City of Portland
Bureau of Development Services
Land Use Services Division

NOTICE OF A TYPE II DECISION ON A PROPOSAL IN YOUR NEIGHBORHOOD

CASE FILE NUMBER: LU 08-118344 AD

Site Address: 2030 SE HAWTHORNE BLVD

GBD-ZONING REQUIREMENT DIAGRAM
3.26.08- ADJUSTMENT REQUEST-REVISED 5.12.08

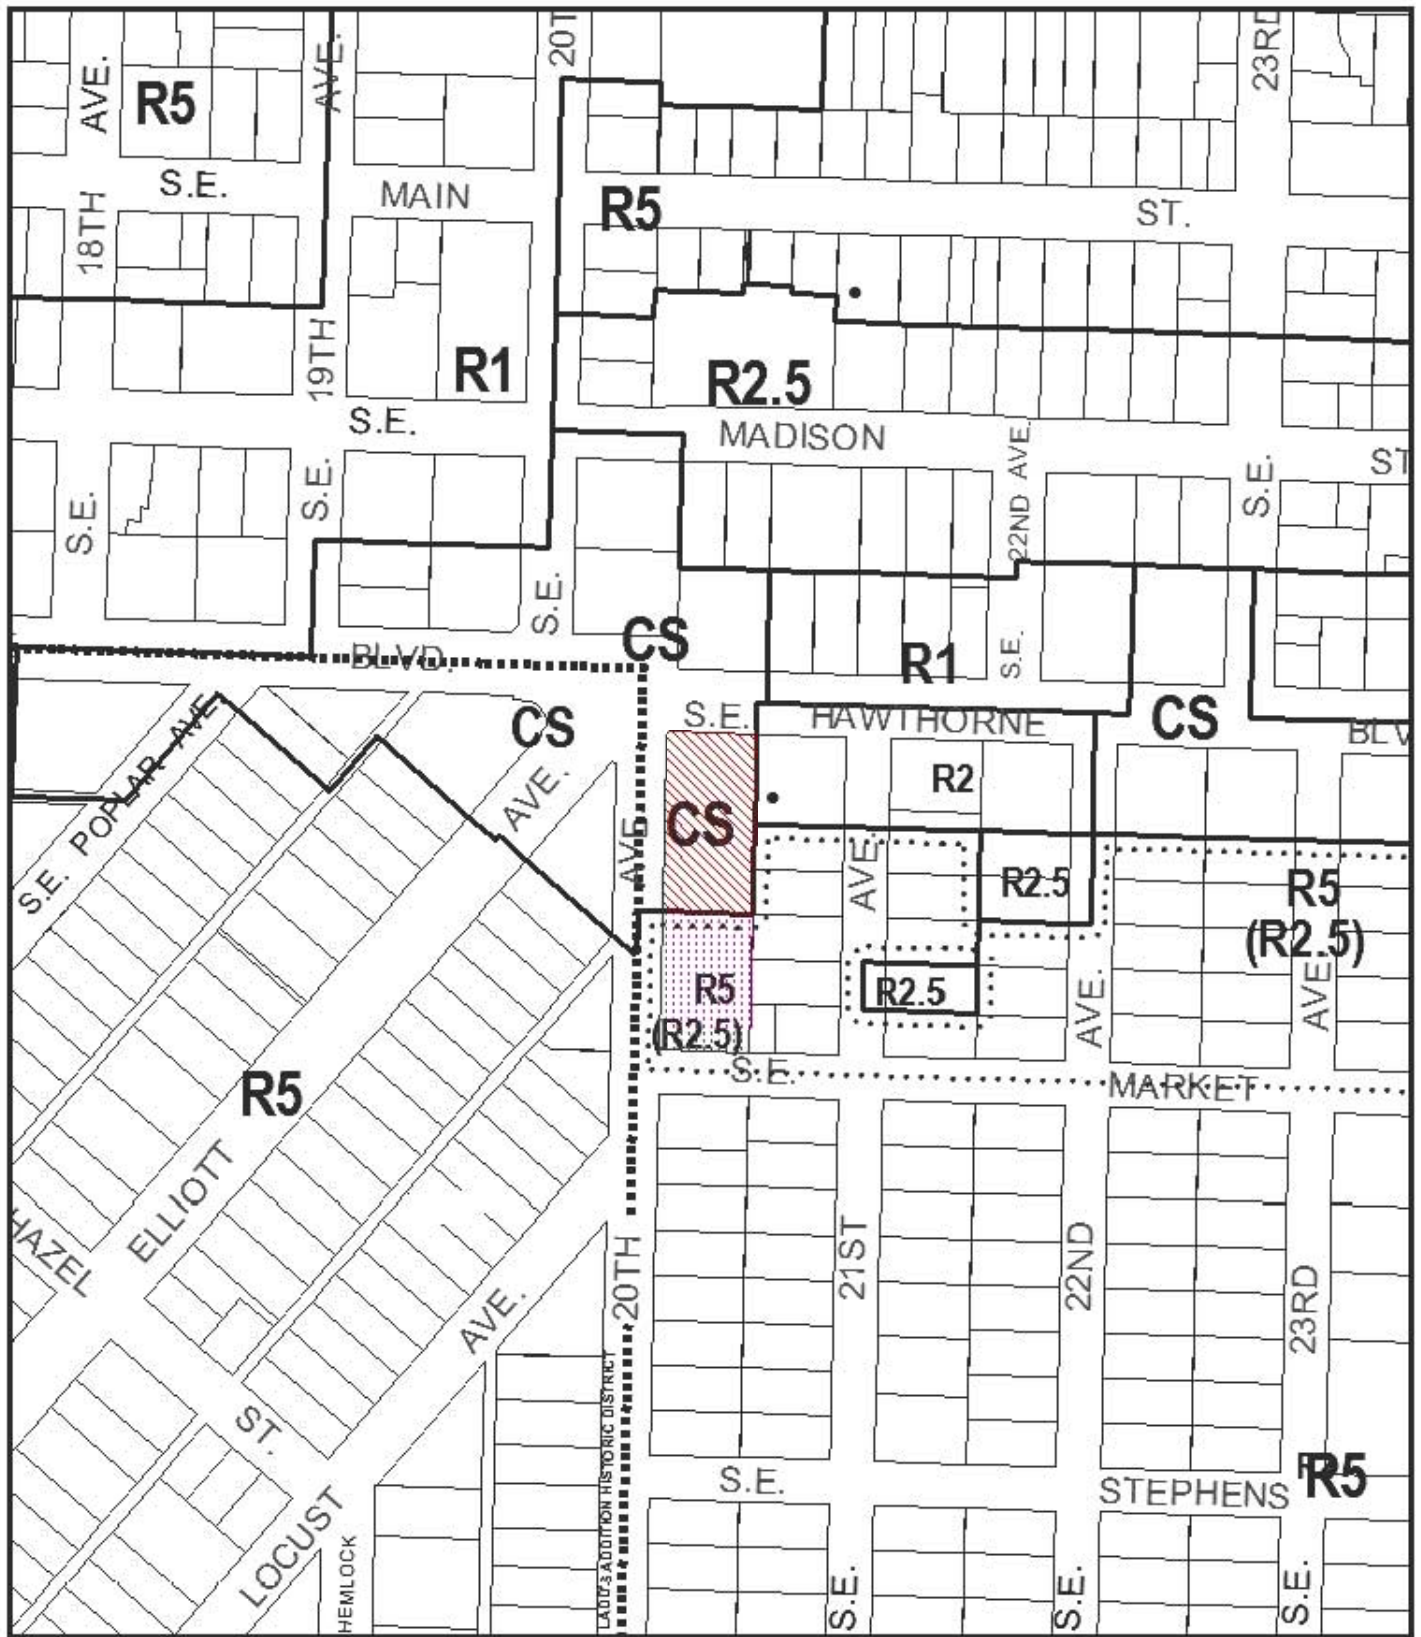
Approval to waive one required on-site loading space and to reduce the size of the second on-site loading space to 26 feet in length, and 8 feet in width

Approved location of reduced size loading space
